# **Review of PREPA Technical Requirements for Interconnecting Wind and Solar Generation**

**Technical Report**  
NREL/TP-5D00-57089  
November 2013

The Puerto Rico Electric Power Authority (PREPA) has established minimum technical requirements (MTR) for interconnection of wind turbine generation and photovoltaic (PV) power plants (see Appendices A and B). During a stakeholder workshop conducted by the U.S. Department of Energy (DOE), the National Renewable Energy Laboratory (NREL), and the Government of Puerto Rico in May 2012, barriers to renewable energy deployment were discussed. The stakeholders, including PREPA, the Puerto Rico Energy Affairs Administration, and representatives from the Governor's Office, requested DOE and NREL assistance in a technical review of the MTRs for variable renewable energy generation.

Figure 1. Comparison of LVRT and HVRT requirements

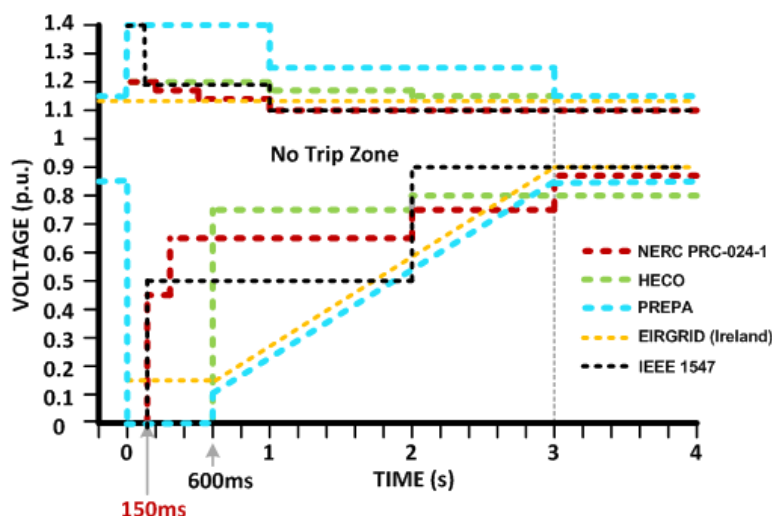
In the original MTR document, PREPA's low-voltage ride-through (LVRT) requirements for both wind and PV are similar. Wind and PV plants are supposed to remain online and ride-through zero-voltage faults for up to 600 milliseconds (ms); this is essentially a zero-voltage ride-through (ZVRT) requirement. The no-trip zone is bounded by linear voltage recovery for up to 3 seconds. PREPA sets high-voltage ride-through (HVRT) requirements for maximum high voltage at 140% of nominal for up to 1 second. A comparison between LVRT and HVRT requirements for PREPA, North American Electric Reliability Corporation (NERC), and other islands systems such as the Hawaiian Electric Company (HECO) and EirGrid are shown in Figure 1.

The draft NERC Protection and Control (PRC) Standard PRC-024-1 requires 150 ms ZVRT. Such ZVRT is a typical requirement for transmission-connected wind power plants (WPP) in the United States. The Federal Energy Regulatory Commission Order 661A also requires 150 ms ZVRT, but recovery time is determined on a site-by-site basis depending on the local grid characteristics and protection schemes. Longer ZVRT requirements are necessary for WPPs connected to weaker lines (typical for smaller island grids). A 600 ms ZVRT requirement is implemented in the HECO system. EirGrid also requires 600 ms ride-through but at 15% voltage and with longer recovery time. Such longer zero-voltage requirements and slower rate of recovery suggested by PREPA is justified for weaker island systems to avoid tripping of the wind generators.

Currently, most U.S. utilities have adopted the Institute of Electrical and Electronics Engineers (IEEE) Standard 1547 for interconnecting distributed resources on the distribution system. IEEE 1547 covers interconnection of all types of distributed energy resources (DER) up to 10 mega volt ampere (MVA) at the point of common coupling. IEEE 1547 clearing times are also shown in Figure 1.

**Figure 2. E-ON reactive current droop**

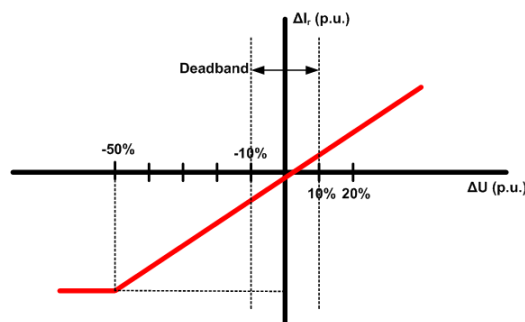
Although it is not necessary for the converter to produce fault current during the fault in the United States, fault voltage support is required by European grid codes. The turbine converter injects reactive current into the fault as a function of percentage of voltage drop. For example, German utility operator E-ON requires reactive current injection according to the droop line shown in Figure 2 (a minimum of 2% positive sequence reactive current for every percent of voltage drop below 100%). This implies that for faults with voltage drops of 50% or lower, the reactive component of current goes to 100% or higher (depending on the current rating of the converter—usually 1.1-1.2 p.u.).

We recommend PREPA further examine the reactive current injection requirement and consider implementation of a similar droop. Currently, PREPA requires that “during the fault conditions, the wind generation facility shall operate on maximum reactive current injection mode.”

In some cases, injecting maximum reactive current may have the opposite effect and cause voltage instability in WPP or PV feeder/collector systems. Implementing reactive fault current droops will help avoid potential instabilities.

### **PREPA’s Response to Recommendation #1:**

In accordance with NREL’s recommendation to further examine the reactive current injection requirement and consider implementation of a similar droop, PREPA revised the MTRs to include the following in the section 1.a.iv:

**Figure 3. Envelope of international LVRT/ZVRT/HVRT requirements**

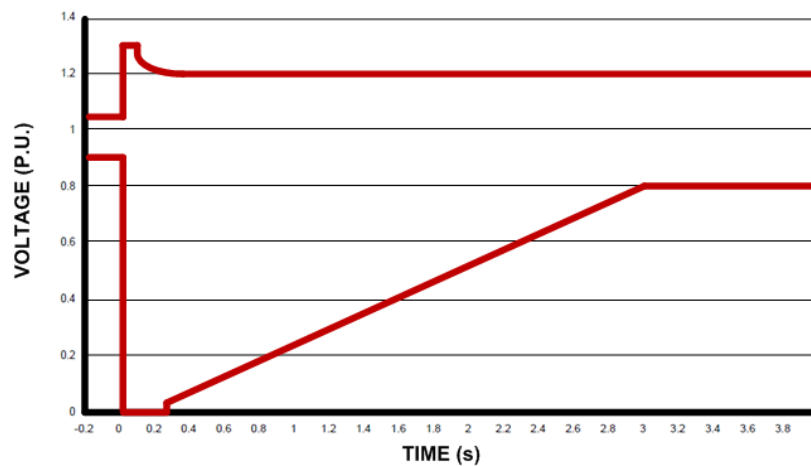
Situations with over-voltages may arise due to sudden load loss, unbalanced faults, and other conditions. The resulting over-voltages may have different magnitudes and durations depending on the scenario. PREPA HVRT requirements (as shown in Figure 1) are the highest compared to various grid codes that can be found in literature [1]. The highest HVRT requirements in some power systems are limited at 130% of rated voltage. In other island systems (such as HECO or EirGrid) the HVRT is limited at 115% to 120%. There are some grids that require 130% HVRT. Boundaries of fault ride-through (FRT) requirements from several European utilities listed in [1] are shown in Figure 3 for reference purposes.

**PREPA's Response to Recommendation #2:**

Based on NREL's recommendation to review the HVRT requirements, PREPA revised the MTRs by reducing the 140% overvoltage ride-through (OVRT) time to 150 ms, and also included a new OVRT range of 130%-125%. The modified section 1.b.i incorporates this new requirement into the following table:

Figure 4. Example of PV plant interconnection with STATCOM on PV collector bus

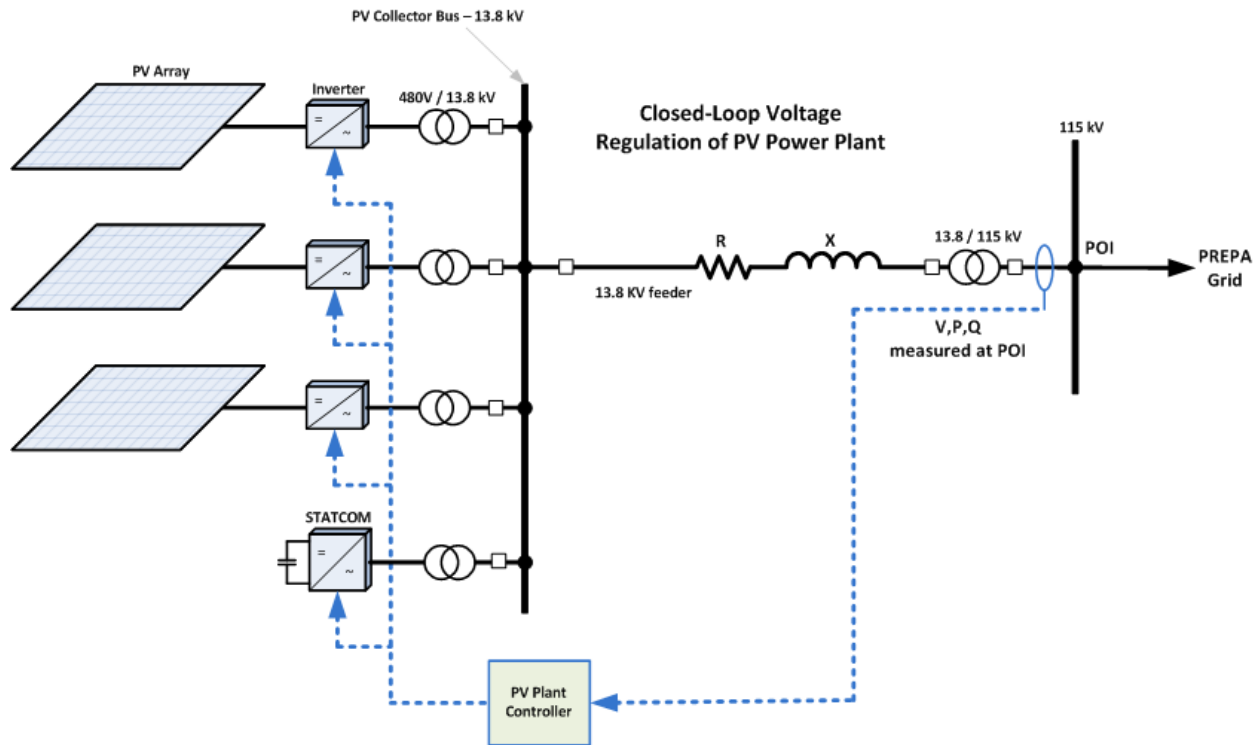
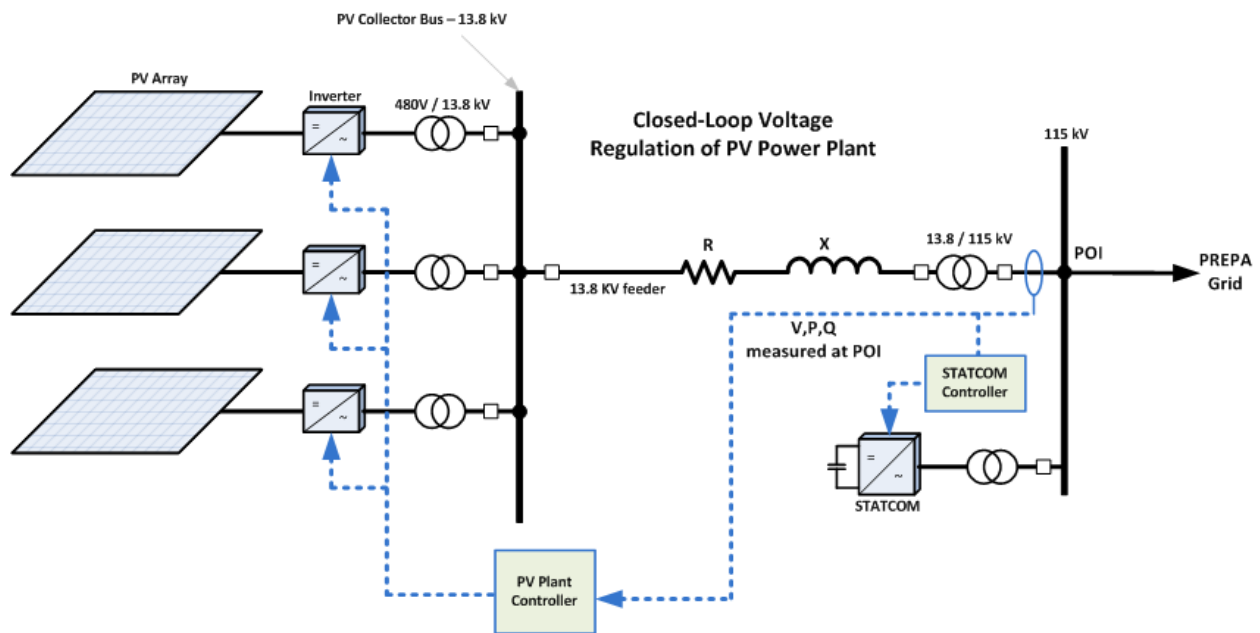
Some examples of closed-loop voltage regulation for PV power plants are shown in Figure 4 and Figure 5 where PV inverters are connected to a 13.8 kilovolt (kV) collector bus, and then to PREPA's 115 kV transmission system via medium voltage (MV) feeder and step-up transformer. The closed loop voltage regulation is performed by a PV plant controller that senses remotely the voltage at the POI. This control loop allows for the best mitigation of voltage fluctuations since it allows eliminating voltage impacts in one location. In the case of other existing feeder voltage regulation (switched capacitors, tap-changing transformers, etc.), there may be some difficulties coordinating PV inverter controls with existing feeder voltage regulation. Care must be taken for PV not to carry an excess share of reactive demand of other feeder loads, avoiding interactions between controls and addressing hunting regulator stability issues.

In cases where voltage control capability of PV inverters is absent (IEEE 1547 compliance) or limited, additional devices such as STATCOM or Static VAR Compensator (SVC) can be implemented on both PV plant collector (Figure 4) or transmission bus (Figure 5) levels. We think that switched capacitor banks or tap changer transformers (in case they already exist in that particular feeder) can be accepted, and in some cases can eliminate a need for additional STATCOM devices. Different regulation strategies can be implemented with these schemes. For example, fast voltage fluctuations can be mitigated with PV inverters, and slower ones can be addressed by the existing feeder equipment. Appropriate time constants must be chosen to coordinate these various controls.

**PREPA's Response to Recommendation #5:**

PREPA's MTR's are specific to transmission (115 kV) and sub-transmission (38 kV) level systems. In PREPA's actual applications, the feeders used by the PV and wind facilities are internal; excess share of reactive demand of other feeder loads is not expected. NREL's comments regarding this issue seem to be more applicable to distribution system feeders. The MTR's actual reactive power requirements provide flexibility for different types of technologies at the renewable energy facility. These technologies include combinations of different equipment like inverters, STATCOMs, SVCs and capacitor banks. As a result, no changes were made to the MTRs.

**Figure 6. Types of reactive power capability curves for wind generators**

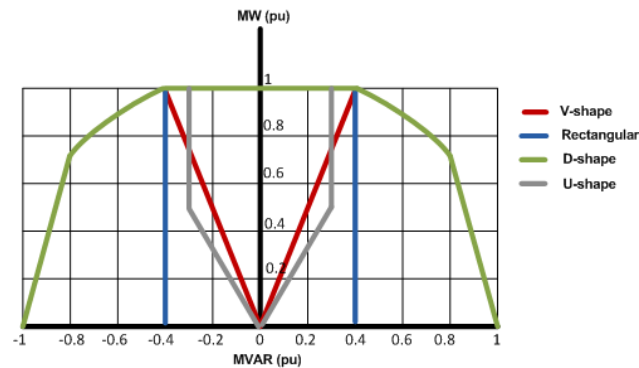
Both double-fed induction generators (DFIG) and full-converter WTGs may come with a variety of V-shape, rectangular, D-shape, or U-shape reactive power characteristics as shown in Figure 6. In some cases, reactive power characteristics can be non-symmetric. One advantage of WTGs with rectangular and D-shape reactive capabilities is the possibility of providing voltage regulation service during no-wind periods. The same is true for PV inverters because they can provide voltage regulation at night by operation in a STATCOM mode.

It is important to note that PV inverters have historically been predominantly designed for deployment in distribution systems in accordance to IEEE 1547, which does not allow voltage regulation. The wind generation was predominantly designed to operate at transmission level, so it is more common for WTGs to come with standard reactive power capabilities similar to ones shown in Figure 6. For PV systems such functionality is not standard and must be explicitly specified in the design stage of the project and in the power purchase agreement (PPA). Also, during periods of no wind or solar resource, both wind and PV generators can still provide reactive power support to PREPA's grid. It makes sense to take this fact into consideration when specifying the reactive power capability since wind and PV inverters may be disconnected from the grid during the periods of no production.

In its minimum interconnection requirements PREPA specifies a rectangular reactive power capability curve for both dynamic and total ranges. A comparison of reactive power capabilities between HECO, PREPA, and EirGrid is shown in Figure 7. Similar rectangular reactive power curves are required by HECO in their model PPA document [2]. EirGrid implemented a U-shaped reactive capability curve that uses a reduced power factor range [or a permissive mega volt ampere reactive (MVAR) range] below 50% or rated power.

**PREPA's Response to Recommendation #7:**

**Figure 7. Comparison of reactive power curves**

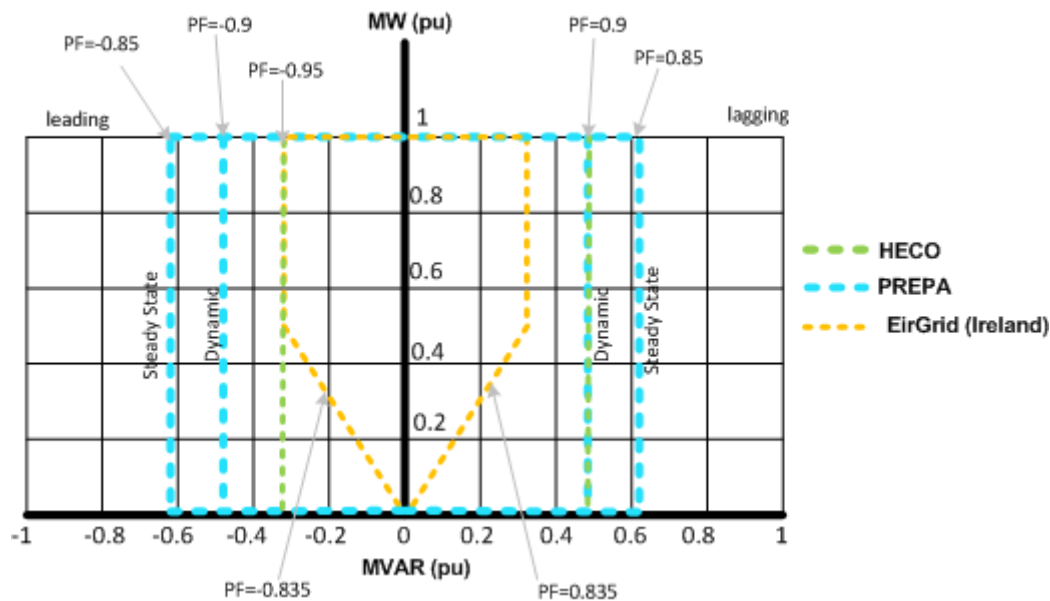
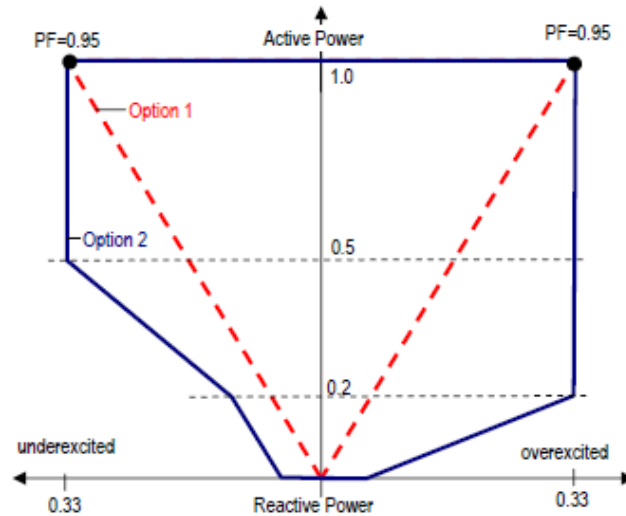
We agree with PREPA that rectangular reactive capability is more beneficial. However, a requirement to maintain reactive power range at full output by PV inverters represents a change with respect to historical industry practice and has some cost impact associated with it. This cost impact could be substantial if the PV plant relies on inverters to provide all required reactive power since additional inverter capacity will be needed. For example, PV inverters would need 11.1% of additional capacity to meet PREPA's dynamic reactive power capability and 17.6% of additional capacity to meet the steady-state reactive power capability. Otherwise, the plant has to be de-rated or external reactive power support needs to be installed.

For some DFIG wind turbine topologies the reactive power capability curves are not symmetrical, as shown in Figure 8 (option 2). This is why permissive MVAR ranges as shown in Figure 7 for EirGrid make sense for systems with DFIG-dominated wind power.

**PREPA's Response to Recommendation #8:**

**Figure 9. LVRT sensitivity to SCR [4]**

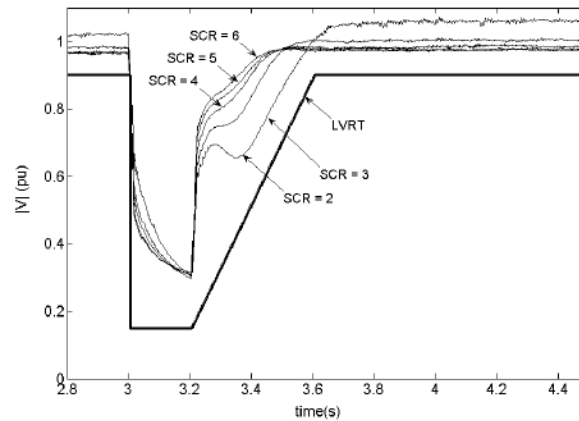
PREPA limits SCR=5 as the minimum permissible level for interconnecting both wind and PV projects. We think this level is adequate. However, we'd like to point out that in some cases even lower SCR might be reasonable assuming LVRT requirements set by PREPA as shown in Figure 1. An example of LVRT sensitivity to SCR for a DFIG wind farm is shown in Figure 9. The turbine speed of recovery degrades as SCR is decreased, but the LVRT requirement is still met even at SCR=2.

### **PREPA's Response to Recommendation #9:**

PREPA maintained the SCR limit on 5. Studies indicate that SCR levels below 5 can cause VRS control instabilities in some applications.

Figure 11. Various frequency droop characteristics

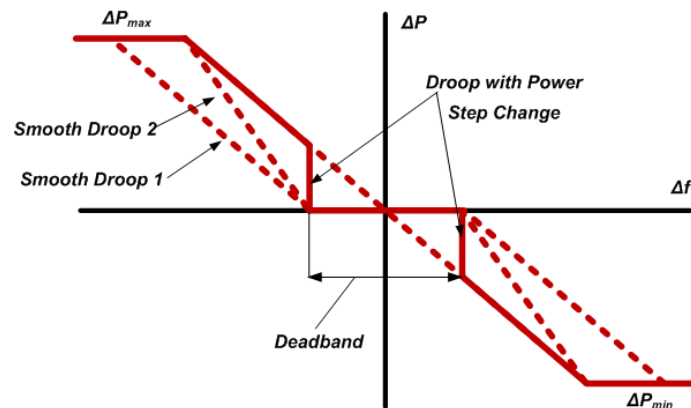
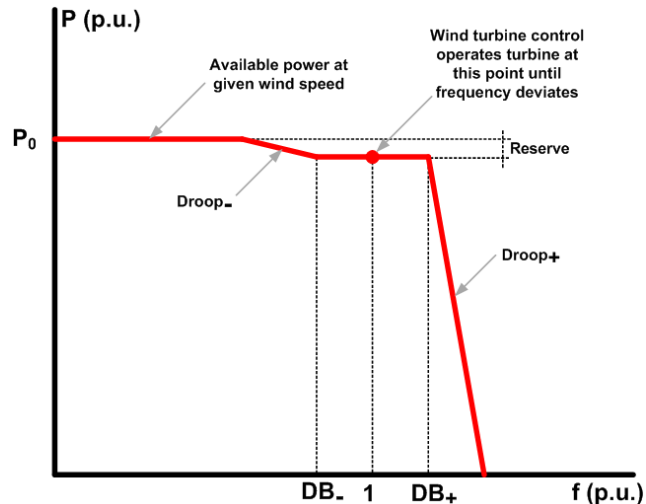
PREPA requires 5% frequency droop for primary frequency control from both wind and PV plants for up and down regulation similar to conventional synchronous generators. This is a symmetrical droop requirement, and PREPA does not specify any dead bands or type of droop characteristic for wind and PV generation. We would like to point out that there are several types of droop characteristics that can be implemented as shown in Figure 11. The Smooth Droop 1 with dead bands is the most common droop used in conventional synchronous generation. The droop curve with power step change is also possible but may cause some stability issues during certain contingency scenarios.

We think that more detailed specifications on the exact type of droop and dead bands would be necessary to remove any ambiguities and misinterpretations for project developers. Primary frequency response (PFR) is one of the most expensive services for renewable generation operators since power reserves must be constantly maintained for up regulation by curtailment (loss of production) or by the use of energy storage devices (extra investment cost).

We would also like to point out that both WTG and PV power plants can reduce their power outputs very effectively so non-symmetric droop characteristics similar to the one shown in Figure 12 can be implemented. Both positive and negative droops and frequency dead bands can be controlled and set by a wind or PV power plant SCADA system to provide aggregate plant PFR that meets power system needs. We recommend PREPA consider the possibility of requesting an option of setting PFR parameters (dead bands, droops, reserve margins) remotely. PFR responses by wind and PV power are additional controls that can be tuned to provide optimum performance and maximum reliability to the PREPA power system and can become a source of additional control flexibility for PREPA system operators.

**PREPA's Response to Recommendation #10:**

Per NREL's recommendation, PREPA added the following clarifications to Section 6:

- The frequency response dead band shall not exceed 0.02%.
- If energy storage systems are utilized to comply with the frequency regulation requirements, and during a disturbance the system frequency stays below 59.7Hz, the facility frequency response shall be maintained for at least 10 minutes.

**Figure 13. Inertial response by type 3 WTG at lower wind speed (NREL model)**

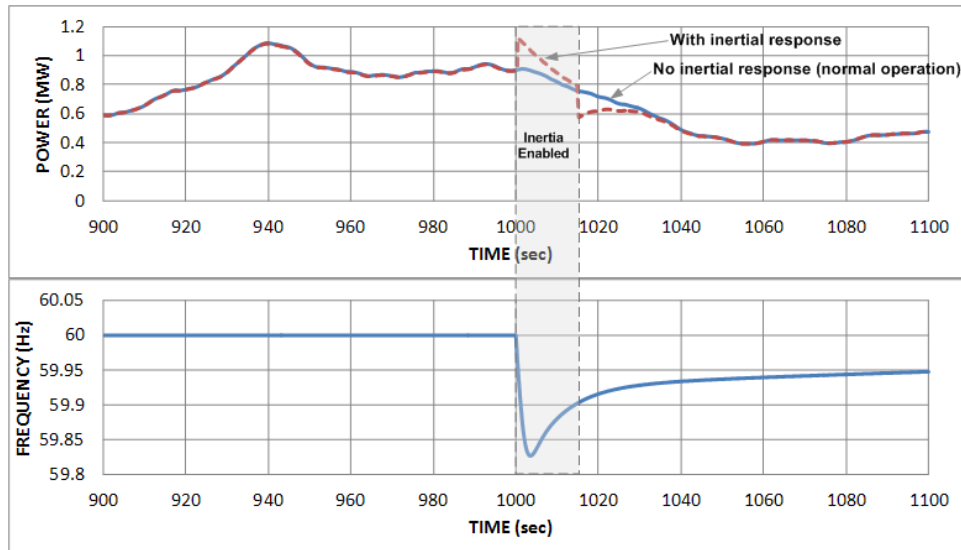
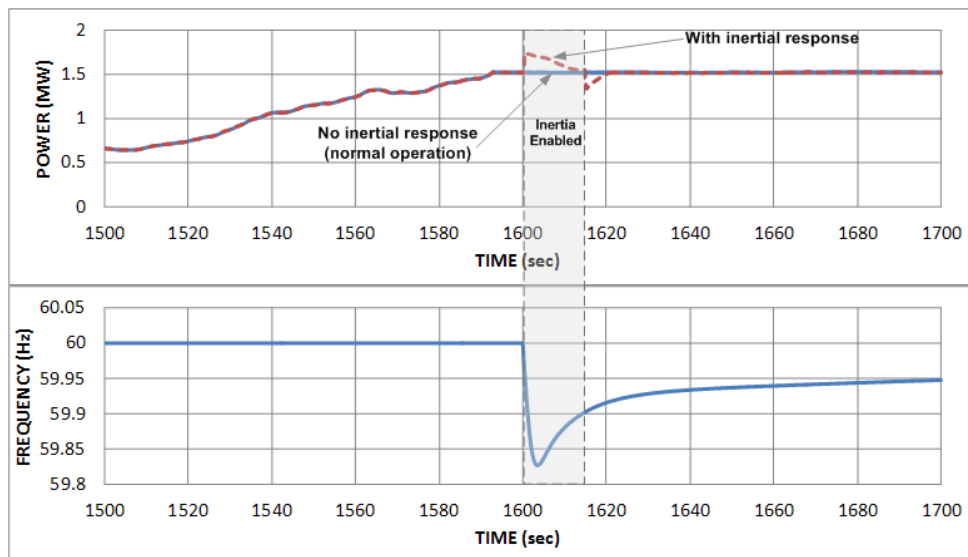
Further, PREPA requires WTG controls to provide inertial response. This requirement also needs more detailed explanation. The main questions here are:

1. What is the priority of inertial response over 10% real-power increase during large frequency declines (more than 0.3 Hz)?
2. What are the dead bands for inertial response for smaller frequency declines?
3. Transition from inertial response to PFR must be specified.

Inertial response by wind power is highly dependent on initial pre-fault conditions of each individual wind turbine (revolutions per minute and wind speed). The aggregate inertial response of the whole WPP will be different than individual WTGs.

Inertial response by wind power is “energy neutral.” Initial periods of overproduction triggered by utilizing rotor inertia are followed by a period of underproduction (someone else needs to meet the load during this period) as shown in Figure 13 and Figure 14. Nevertheless, the overall benefit of such inertial response is significant because it helps the power system in the form of arresting initial rate of change of frequency and “gaining time” for a slower PFR of conventional generation.

The recovery period and return to normal operations after providing inertial response can be different depending on the available wind resource. At rated wind speed (Figure 14) the return to pre-disturbance level is much faster than at lower wind speed (Figure 13) because of more favorable conditions (there is power available from wind to provide incremental electric power).

**PREPA's Response to Recommendation #12:**
